CONDITIONS OF APPROVAL:

Engineering - PUD Plan Checklist

Southbrooke PUD Subdivision Development Plan Initial Submittal - 04-08-2019.pdf

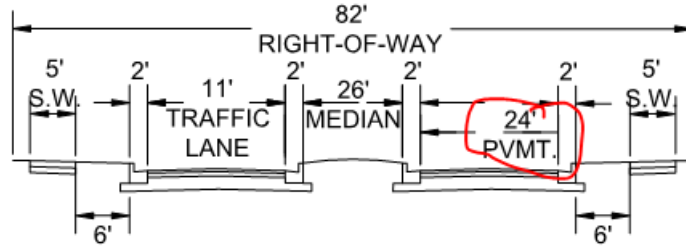
Remove the typical sections from the ROW & Access plan sheets and put them on a separate sheet. Label all streets as per their classifications. All interior streets should be Intermediate or Low Volume Local; Alley; or a variation of such (e.g. w/ on-street parking.)

The Lewisburg Pike typical should match the City's COF TS-02 typical standard (Major Arterial).

McLemore should be a Minor Collector similar to TS-08, as modified by Comment #58.

The one-way street section is a renamed alley and not acceptable. Only alleys are not required to have sidewalks, and appropriate raised curb sections are required for streets, not ribbon curbs.

Sidewalks on arterial and collector streets should be 6' in width.

Clarify what the 24' measurement on typical is referring to, or correct if in error:

If there is no difference between the "2-LANE BOULEVARD INTERMEDIATE AND LOW VOLUME STREET (AREA A)", "2-LANE BOULEVARD INTERMEDIATE AND LOW VOLUME STREET (AREA D)", and "2-LANE BOULEVARD INTERMEDIATE AND LOW VOLUME STREET (AREA E)", only show one and specify "2-LANE BOULEVARD INTERMEDIATE AND LOW VOLUME STREET (AREAS A, D & E)."

road typical sections moved to sheet c4.06

FUTURE ARTERIAL STREET (LEWISBURG PIKE)

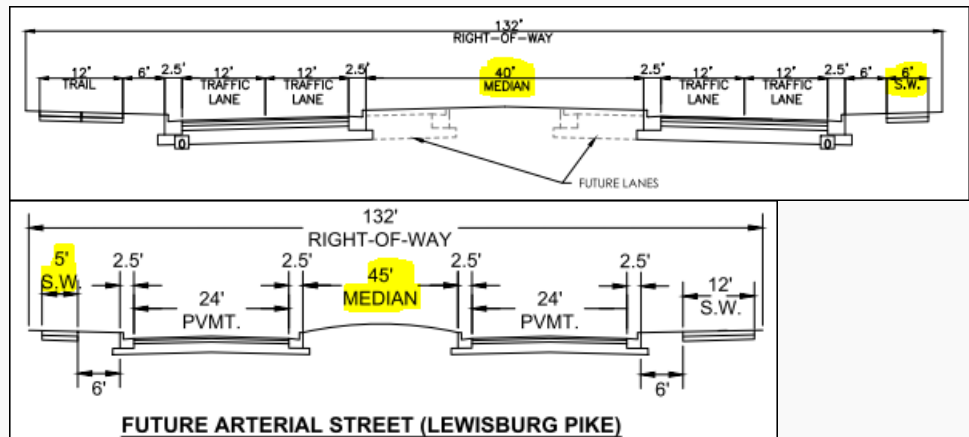
Applicant to revise Lewisburg Pike section (C4.6) and associated drawings to match that shown in the Comprehensive Transportation Network Plan and Street Specifications.

Section has been updated to match future proposed improvements on Lewisburg Pike.

COLLECTOR STREET (MCLEMORE ROAD)

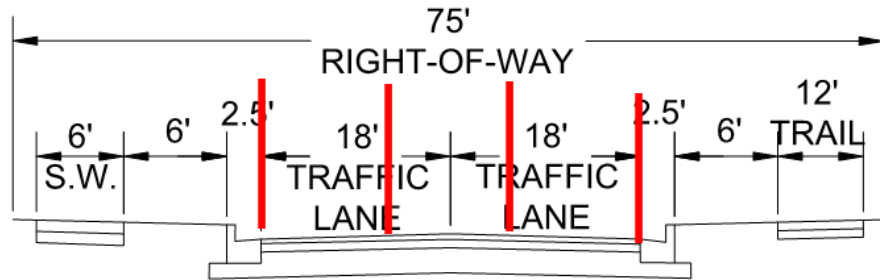
Applicant shall revise dimensions on typical sections to identify lanes as Travel, Turning, or Parking. The City of Franklin does not allow "yield streets" with excessively wide or narrow lanes.

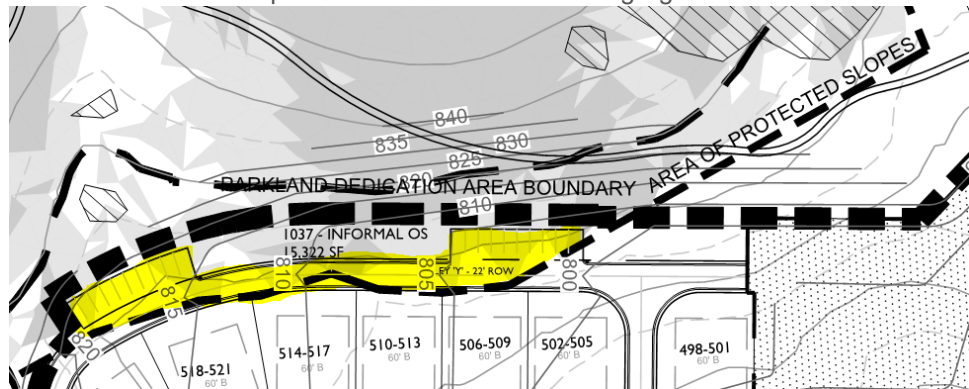
lance.fittro@franklintn.gov In order to ensure safe circulation for Fire and service vehicles through the alleys shown on the development plan, where perpendicular parking off of the alleys are proposed, these parking areas shall provide a minimum of 5 feet from the edge of the alley pavement to the end of the parking stalls. Minimum parking stall dimensions shall then be the standard 9 ft (width) x 18 ft (depth), with end stalls being 10 ft in width. No reduction in stall dimensions for compact parking spaces shall be permitted for parking off of alleys.

lance.fittro@franklintn.gov The previous comment has been addressed with the provided layout linework (thank you). Applicant shall provide dimensions for the alley perpendicular parking pads on the layout view or (preferably) provide a typical section for the alley perpendicular parking pads with dimensions to provide guidance for site plan submittals to follow.

greggamble209@gmail.com Parking lots have been updated.

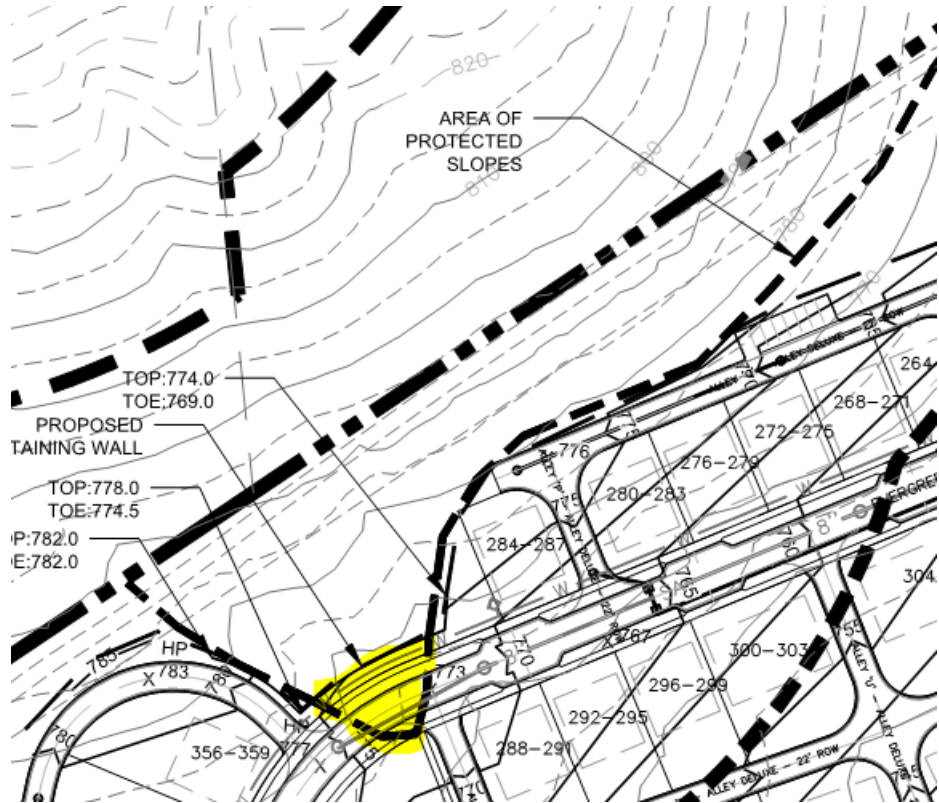
Applicant shall remove all proposed development, including streets, alleys, off-alley parking areas, and associated grading and retaining walls, from the "Area of Protected Slopes" identified on the Development Plan. One such area that persists is highlighted below:

greggamble209@gmail.com This comment is no longer applicable; layout has changed.

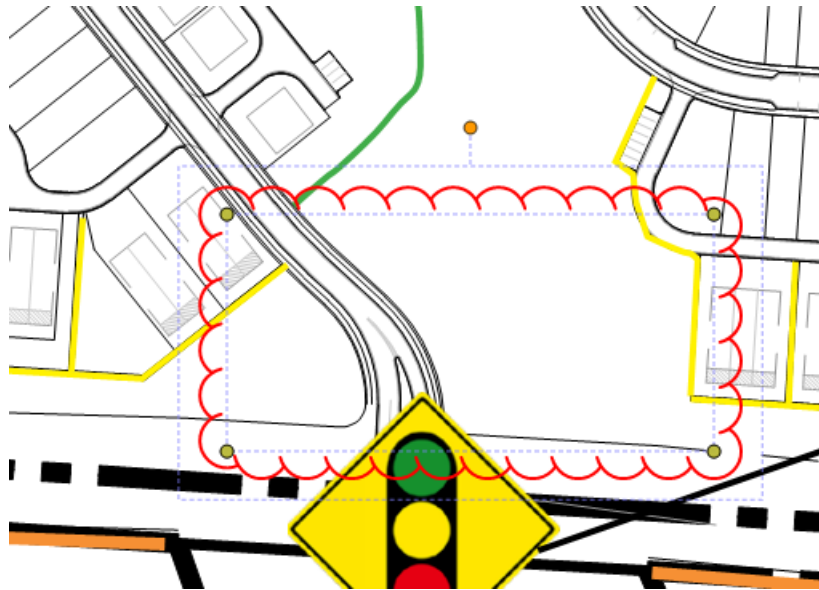
Sidewalks will be required along the entirety of the Lewisburg Pike frontage, either along the existing roadway, at the location of the future sidewalk with the eventual widening of Lewisburg Pike, or along the frontage of the proposed lots. (This would appear to be the most desirable option at the current time.) Also, all alley loaded lots must be served by sidewalk somewhere, so the Lewisburg frontage seems to make the most sense.

kevin.long@franklintn.gov Comment partially addressed.

Applicant shall provide a pedestrian connection along the western side of Lewisburg Pike in the northern portion of Area 'C'.

greggamble209@gmail.com Pedestrian plan has been updated with additional sidewalks.

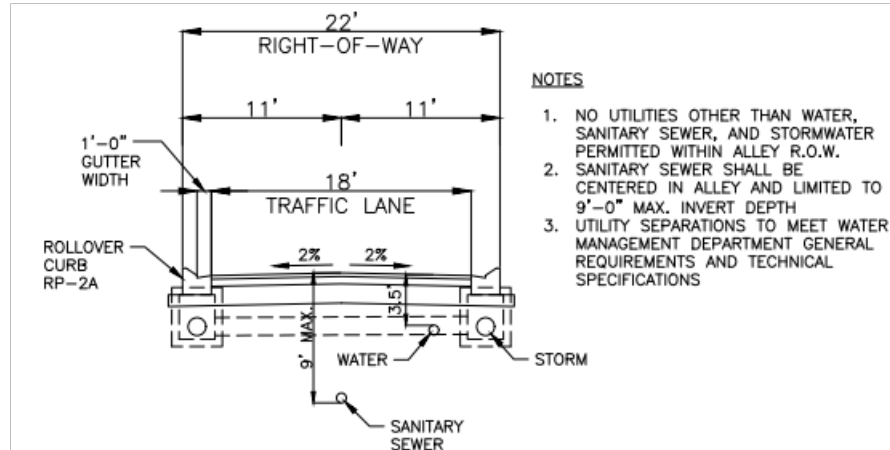
kevin.long@franklintn.gov Applicant shall update sheet 4.6 to reflect conditions outlined in comment 192 from Jimmy Wiseman:

- Provide dual northbound right turn lanes and dual northbound through lanes on Lewisburg Pike.
- Provide dual westbound left turn lanes, a westbound through lane and a dedicated westbound right turn lane on Goose Creek Bypass as well as a southbound receiving lane on Lewisburg Pike.

greggamble209@gmail.com Sheet added. C4.6

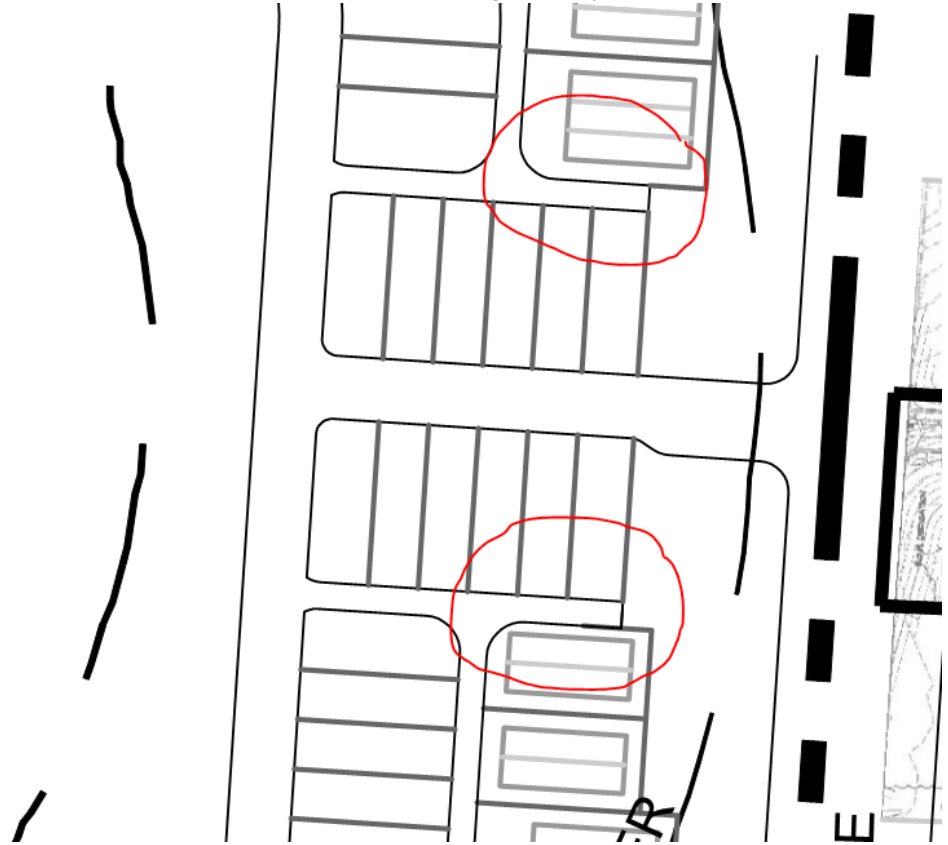
Section 2.3.7 of the Franklin Transportation & Street Technical Standards prohibits permanent dead-end streets/alleys without cul-de-sac designs. The dead-end alleys shall be removed and connected back to the right-of-way.

Street layout has been revised.

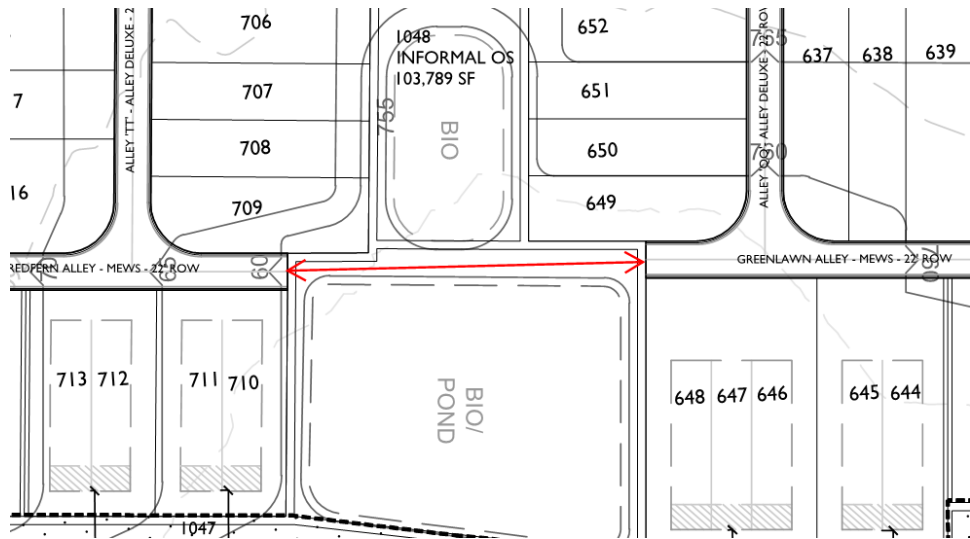
The applicant shall connect the alley section on sheet C2.5 as well.

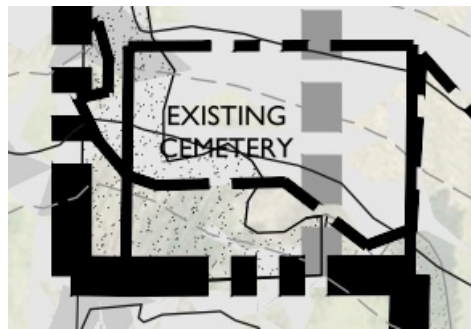
joe.marlo@franklinton.gov Applicant to verify if a cemetery exists or not on the property. If it does not exist, Applicant to remove all notes for 'Existing Cemetery', including those on C1.5.

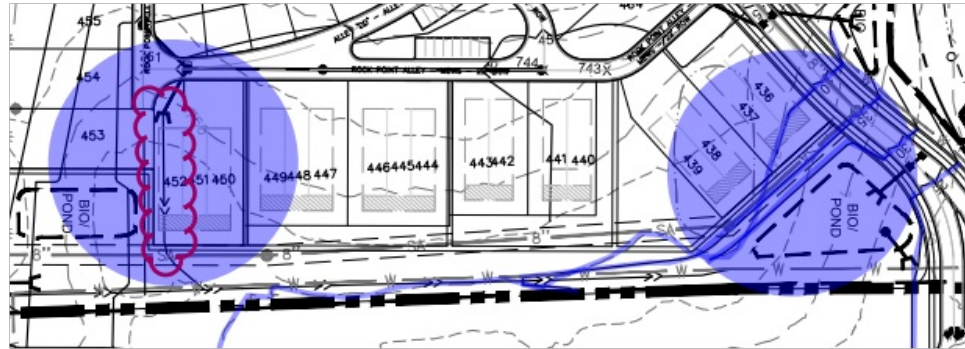
Advisory Comment: Bioretention areas are to be constructed level. Several bioretention areas shown on the Development Plan appear to be on sloping grades.

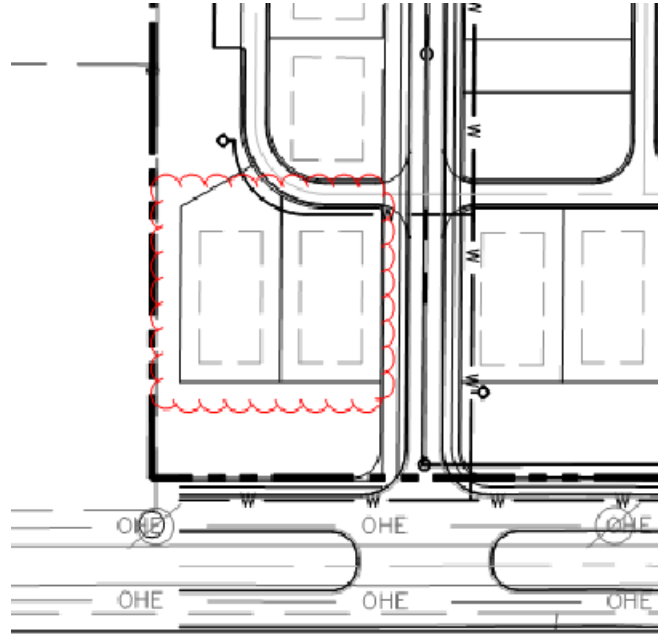
ben.mcneil@franklintn.gov The applicant has provided the off-site sewer infrastructure, but did not include existing conditions. The applicant shall provide all existing conditions in the layout for review of the proposed routing.

ben.mcneil@franklintn.gov The applicant did not fully address the issue, the existing conditions that have been provided do not have enough information for a complete review of the layout. The existing sanitary sewer locations shall be shown, the stream banks, buffers and all required information needed to ensure the layout will meet requirements. at site plan this must meet all Franklin Water requirement.
[Edited By Ben McNeil]

greggamble209@gmail.com Existing conditions added to sheet C5.6-C5.8.

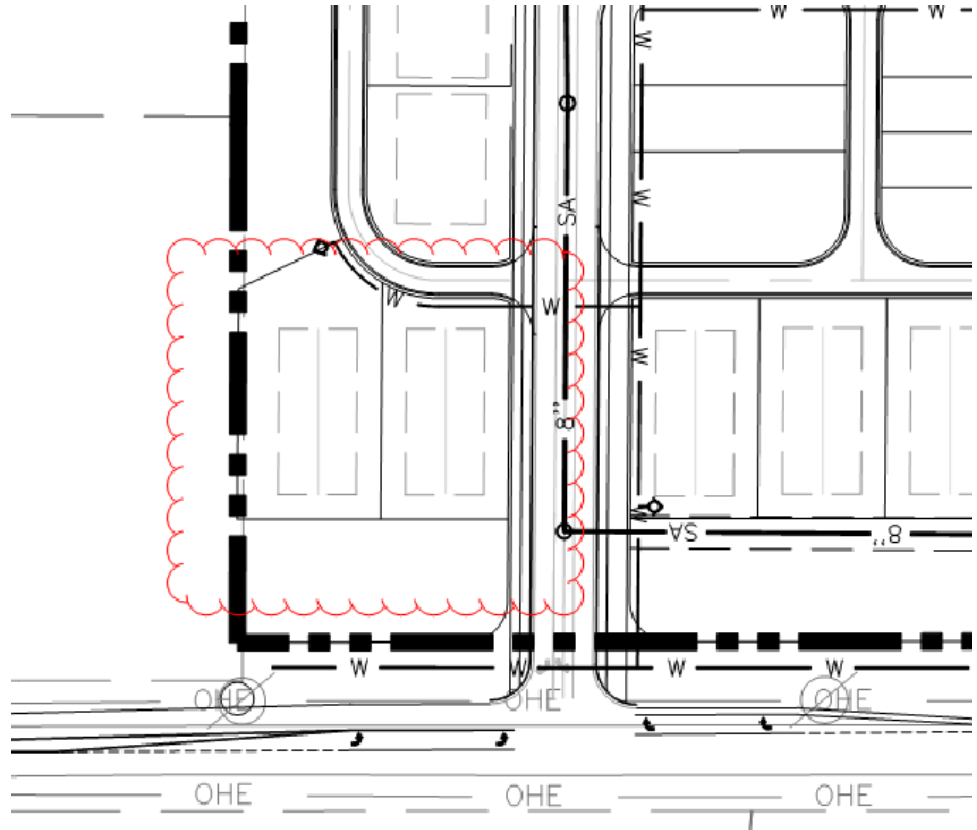
The applicant shall show how each lot will be served by sanitary sewer . The lot depicted below does not show sanitary sewer service.

Sewer extended to west to serve 2 lots

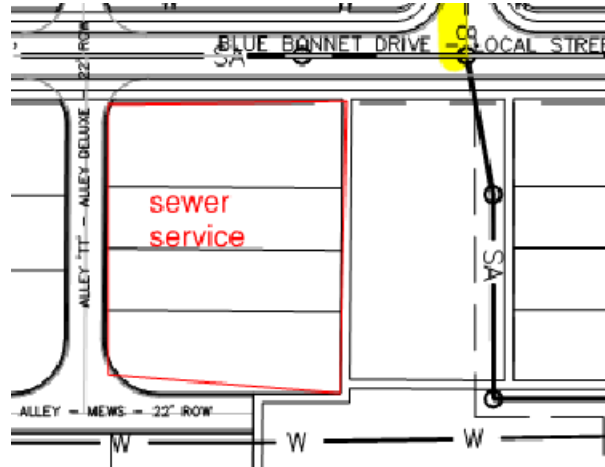
The applicant has lots shown that are not served by sanitary sewer, the applicant shall ensure that all lots are served by sanitary sewer.

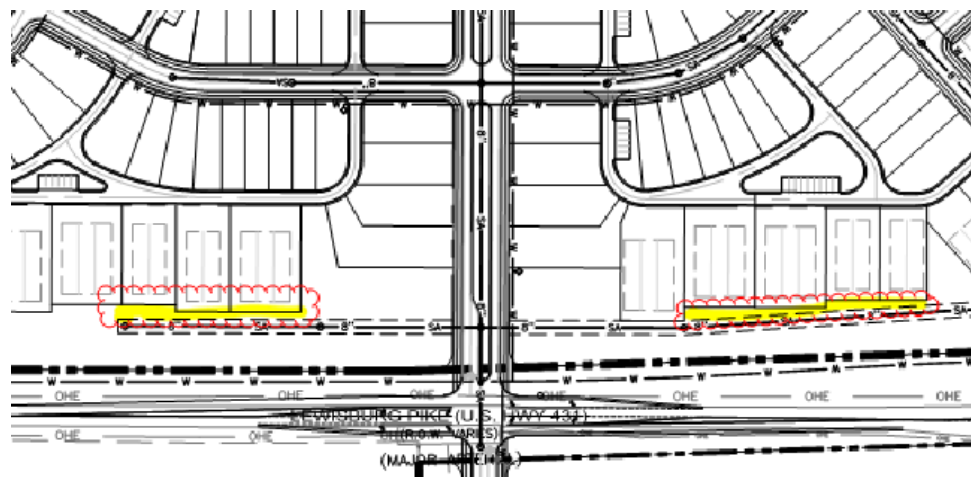
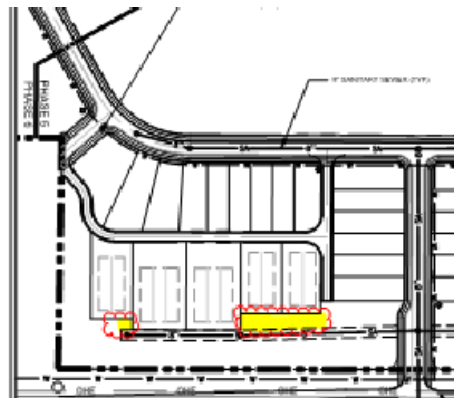
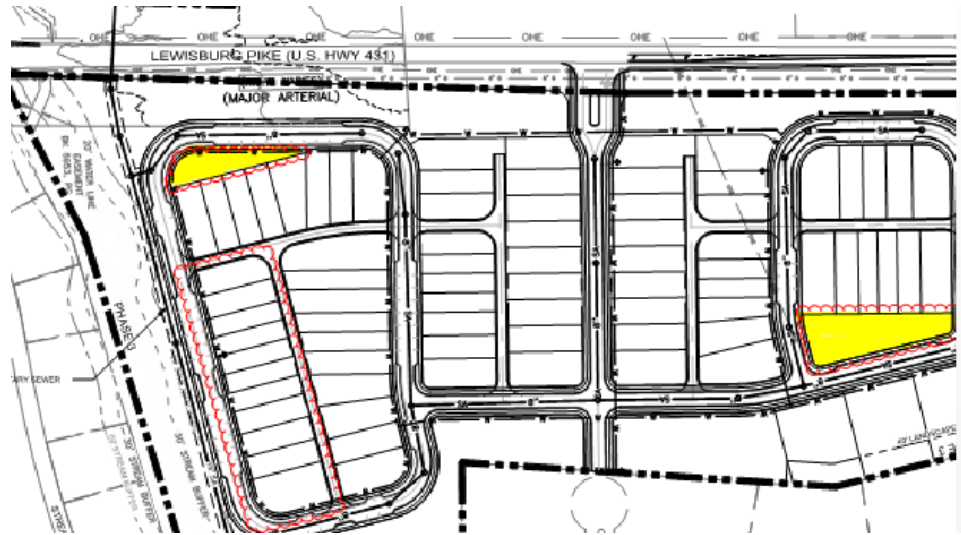
The sanitary sewer shall be designed to ensure that COF sewer service lines do not cross open space areas. The sanitary sewer mains shall be designed to limit this. In addition, sanitary sewer mains shall be minimized where possible to limit the amount of infrastructure that will serve this development.
[Edited By Ben McNeil]

sewer locations revised as discussed with staff

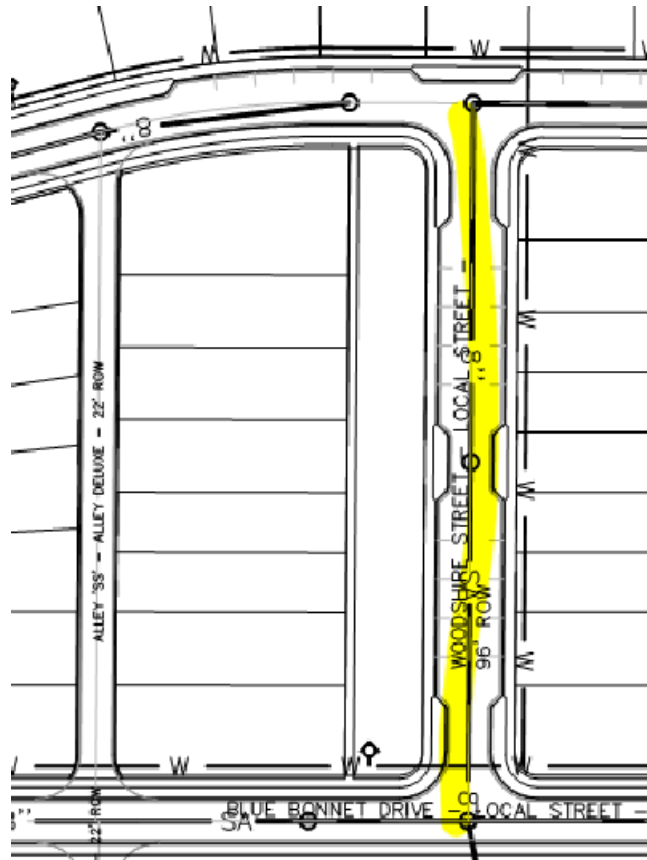
The applicant failed to address the issue. The sanitary sewer shall be designed to ensure that COF sewer service lines do not cross open space areas. The sanitary sewer service lines do cross open space areas as shown below.

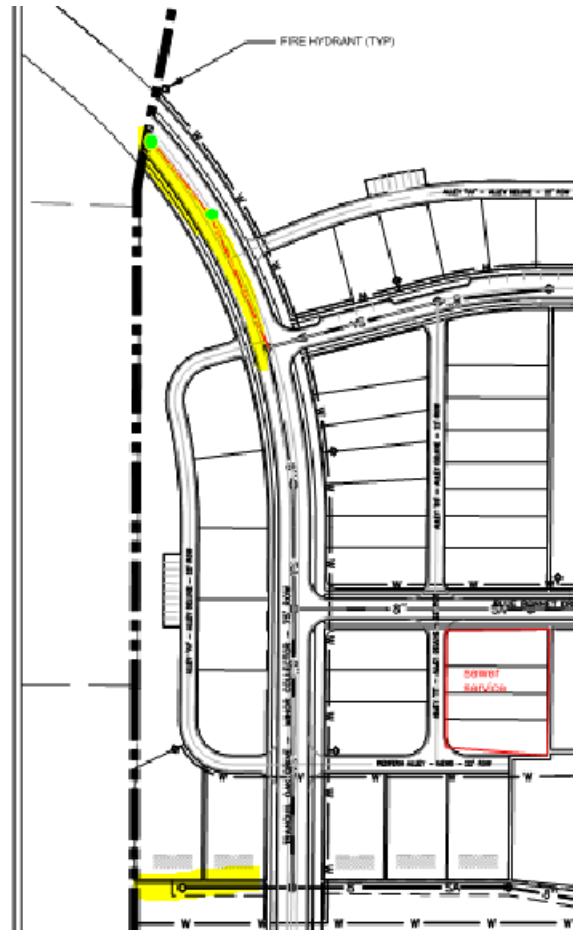
The sanitary sewer main shall extend to the south west property line to extend and serve future drainage areas.

extended sewer main

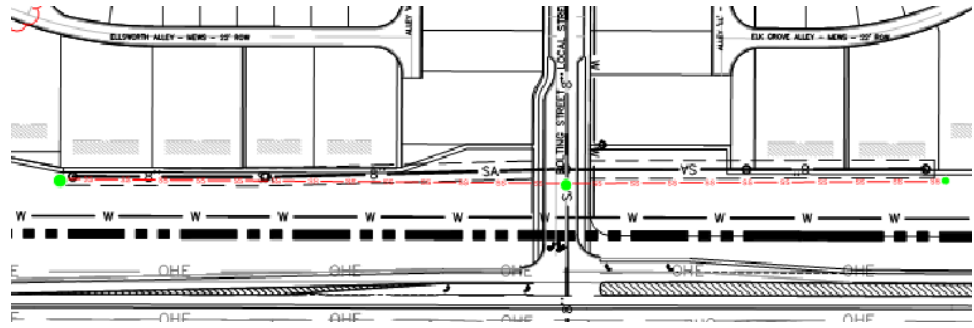
ben.mcneil@franklin.tn.gov The applicant shall show the sanitary sewer main and easement off of the proposed lots. The picture below appears to have the sanitary sewer easement shown on the proposed lots. This applies to all similar areas.

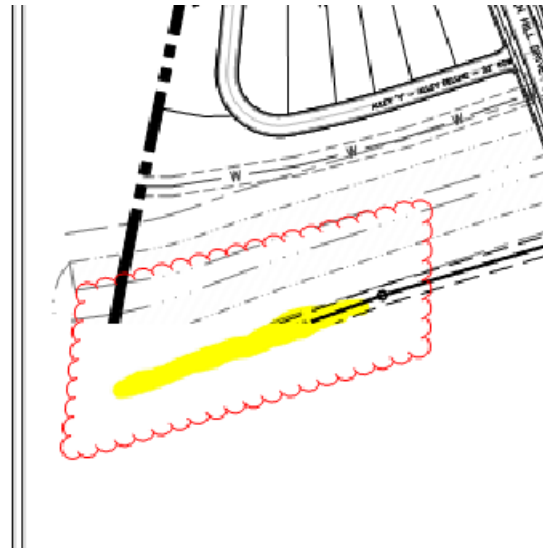
ben.mcneil@franklin.tn.gov The applicant shall show the full extent of the proposed sanitary sewer to the property line
